PROJECT: Office Renovation and Addition for
City of Huber Heights Tax, Finance & Water Departments

ADDENDUM NO. 3

ITEM M1 DRAWING, H0.4

H0.4

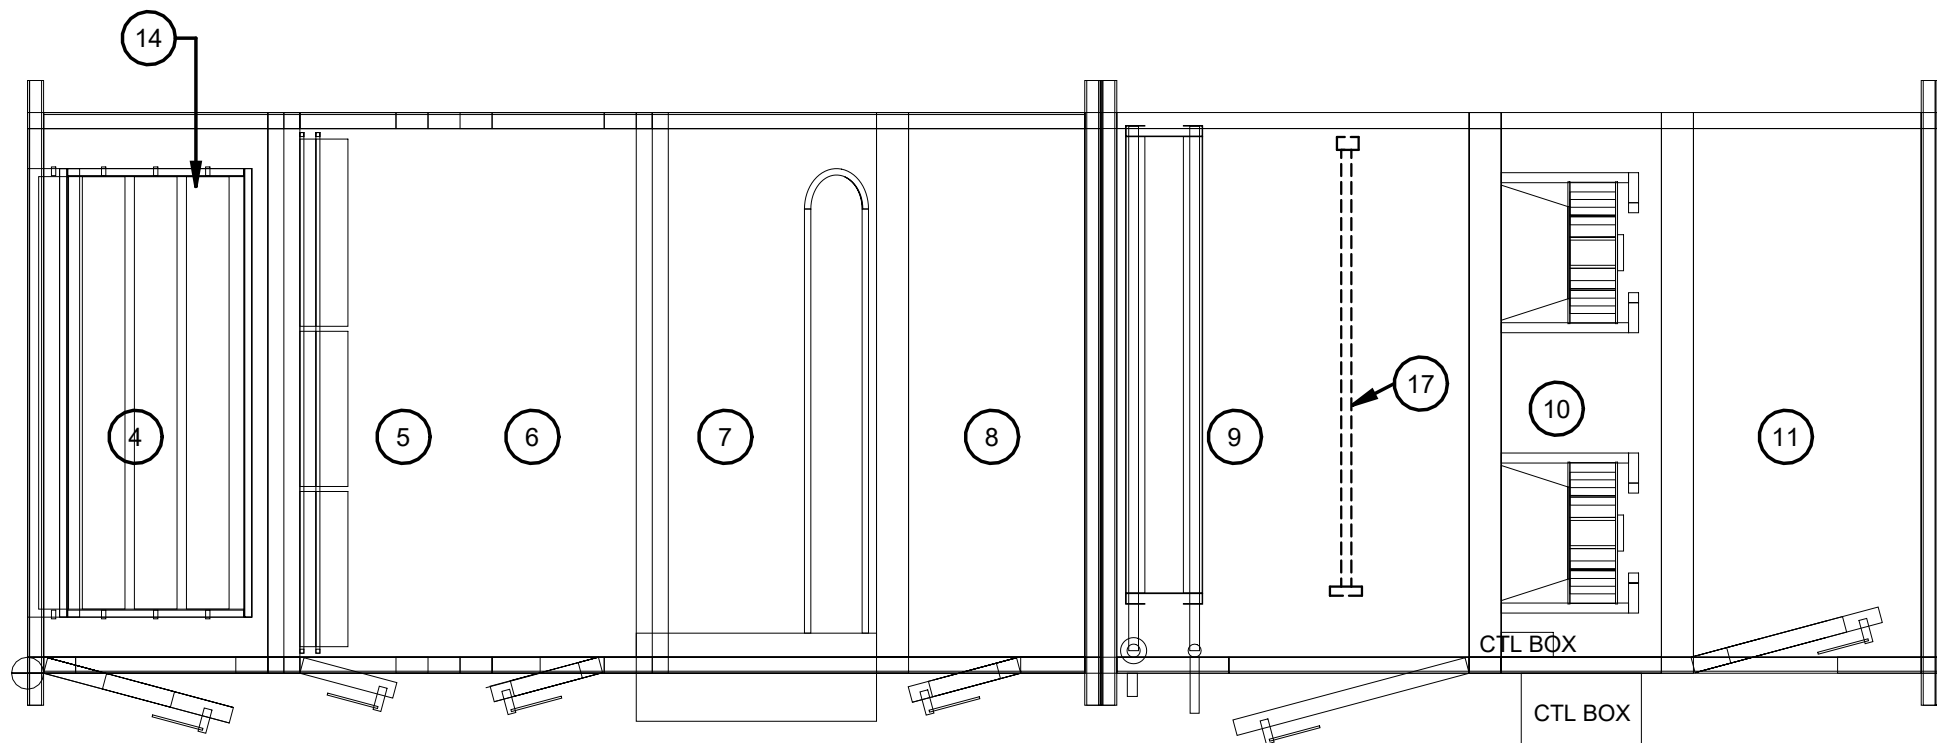
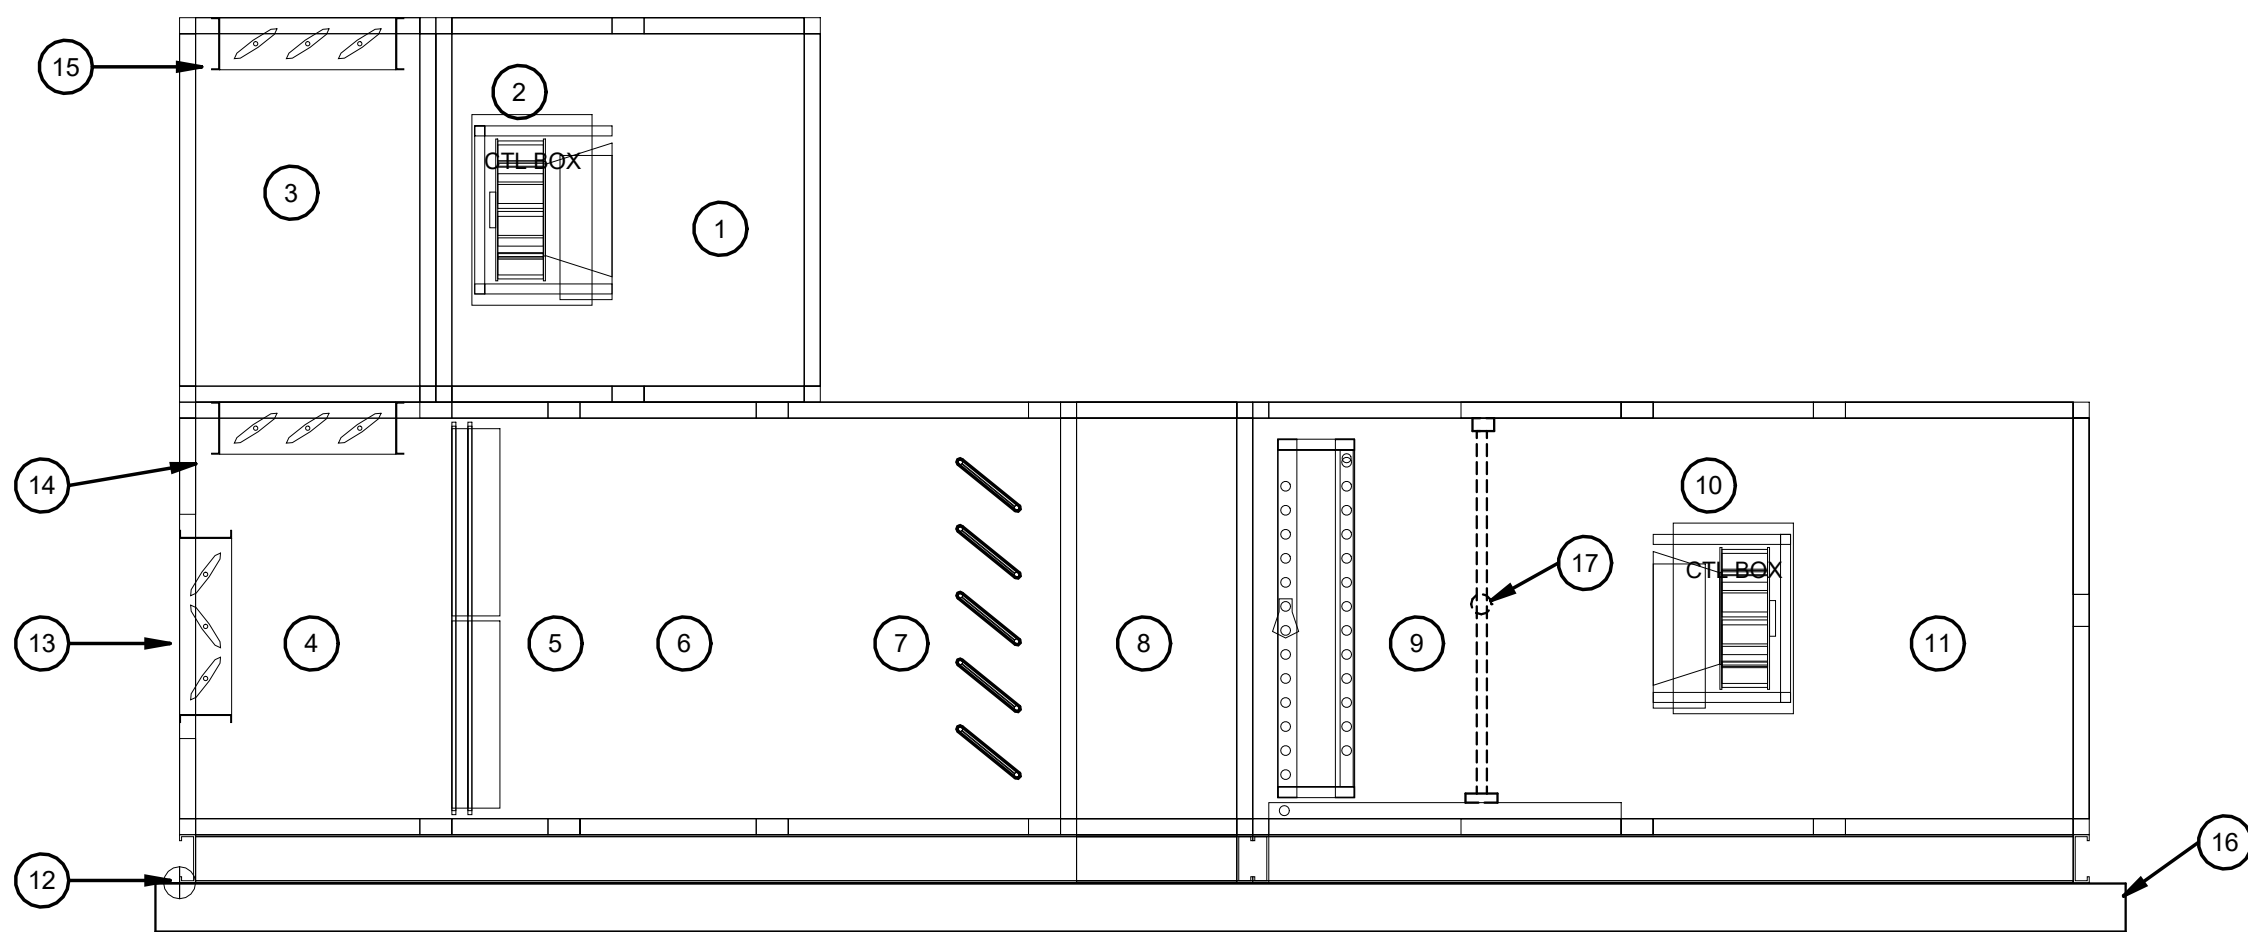
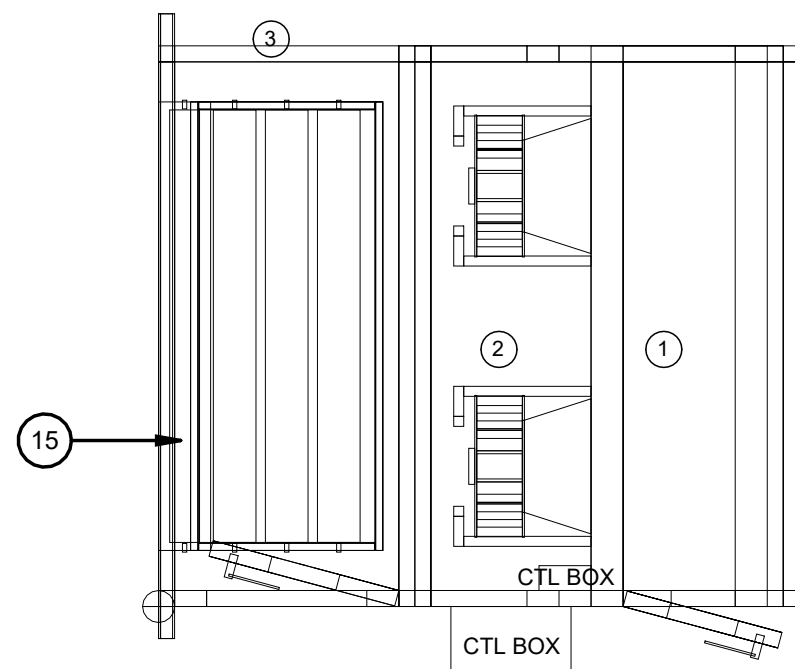
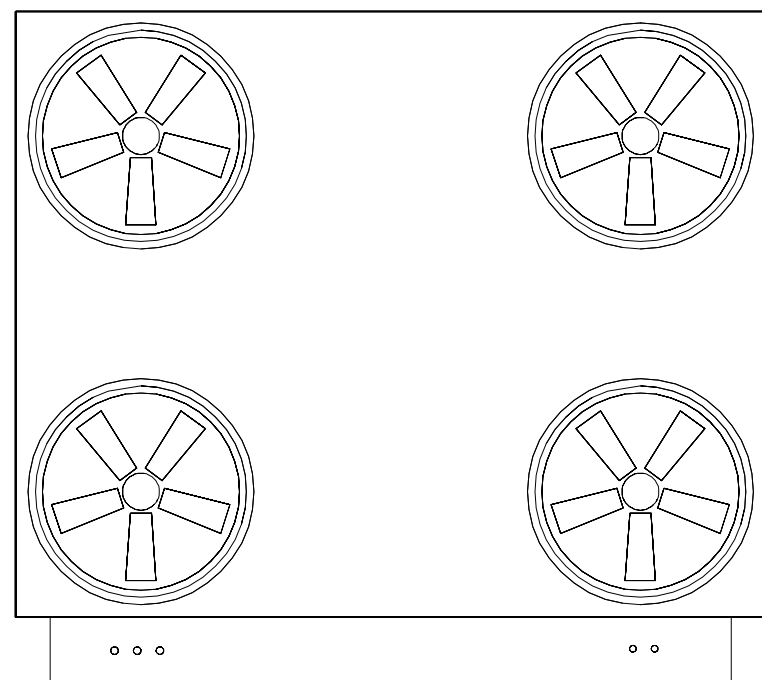
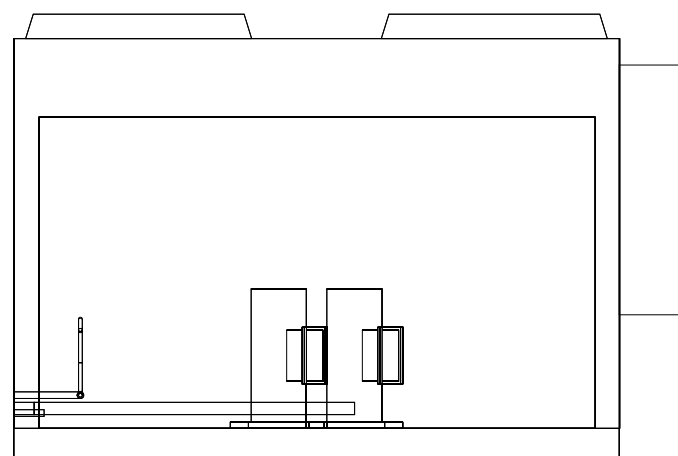
1. Deleted Note 1 about pre-purchase of air handling unit and condensing unit from the General AHU Notes. Items are to be included in bid.
